SERVICE INSTRUCTION

Introduction of new exhaust system components and assemblies for ROTAX® 912 (Series) and 912 i (Series) Aircraft Engines

ATA System: 78-10-00 Exhaust System

Fig. 2

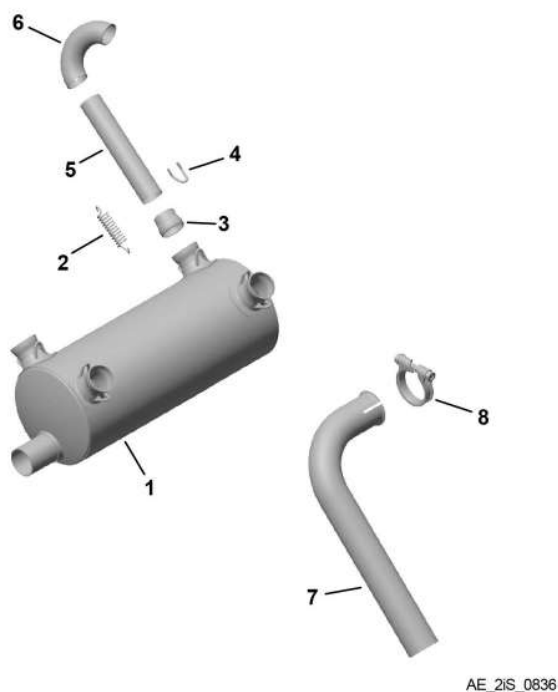
Fig.no.	New part no.	Qty/ engine	Description	Old part no.
2	978489	(1)	EXHAUST ASSORTMENT STAINLESS STEEL	
Consists of:				
2-1	978064	1	MUFFLER ASSY. STAINLESS	978063
2-2	938796	8	SPRING 66 MM STAINLESS	
2-3	978521	4	BALL JOINT MALE STAINLESS	
2-4	853356	8	HOOK STAINLESS	
2-5	978998	2	EXHAUST TUBE 800 MM STAINLESS	
2-6	978500	2	EXHAUST ELBOW ASSY. 360 DEGR. STAINLESS	
2-7	978605	1	EXHAUST ELBOW STAINLESS (TAILPIPE)

Muffler assy. 978064/978063 (0° bend angle) is for use with 80 HP engine only! Do not use on 100 HP engine.

Fig. 3 912 UL, ULS, iS (Series)

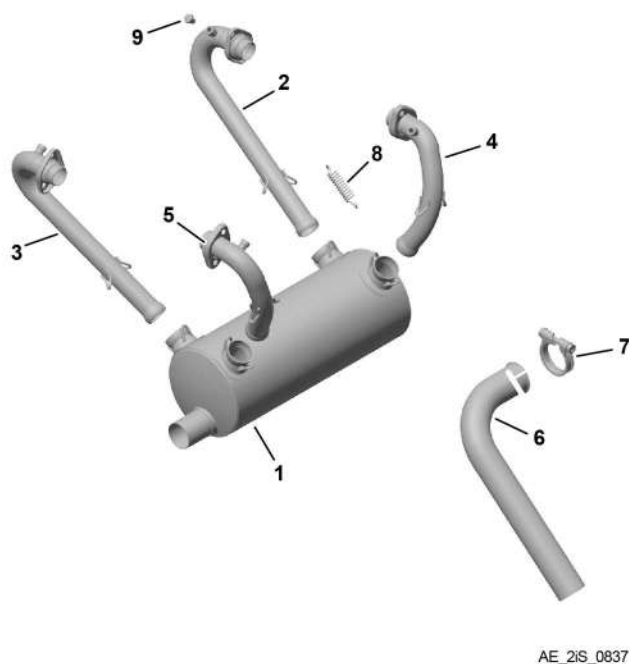
Fig.no.	New part no.	Qty/ engine	Description	Old part no.
3	973383	(1)	EXHAUST ASSORTMENT STAINLESS STEEL	973380
Consists of:				
3-1	973388	1	MUFFLER ASSY.	973385
3-2	973013	1	EXHAUST PIPE ASSY. CYL. 1	973010
3-3	973023	1	EXHAUST PIPE ASSY. CYL. 2	973020
3-4	973033	1	EXHAUST PIPE ASSY. CYL. 3	973030
3-5	973043	1	EXHAUST PIPE ASSY. CYL. 4	973040
3-6	973389	1	EXHAUST ELBOW STAINLESS (TAILPIPE)	973390
3-7	951552	1	EXHAUST PIPE CLAMP ASSY. 42 MM	951550
3-8	938796	9	SPRING 66 MM STAINLESS	
3-9	841115	4	HEX. SCREW M8X1X10

Muffler assy. 973388 has a tailpipe diameter of 42 mm and a bend angle of 0°, use with 973389 elbow (90° bend angle). Muffler assy. 973385 has a tailpipe diameter 40 mm and a bend angle of 3°, use with 973390 elbow (93° bend angle).

Fig. 4

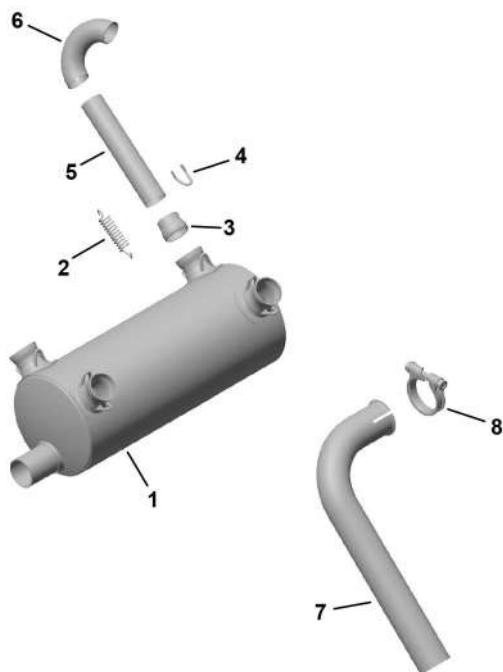
Fig.no.	New part no.	Qty/ engine	Description	Old part no.
4	973677	(1)	EXHAUST ASSORTMENT STAINLESS STEEL	973676
Consists of:				
4-1	973673	1	MUFFLER ASSY. STAINLESS	973674
4-2	938796	8	SPRING 66 MM STAINLESS	
4-3	978521	4	BALL JOINT MALE STAINLESS	
4-4	853356	9	HOOK STAINLESS	
4-5	978998	2	EXHAUST TUBE 800 MM STAINLESS	
4-6	978500	2	EXH.ELBOW ASSY. 360 DEGR. STAINLESS	
4-7	973389	1	EXHAUST ELBOW STAINLESS (TAILPIPE)	978605
4-8	951552	1	EXHAUST PIPE CLAMP ASSY. 42 MM	951550

Muffler assy. 973673 has a tailpipe diameter of 42 mm and a bend angle of 0°, use with 973389 elbow (90° bend angle).
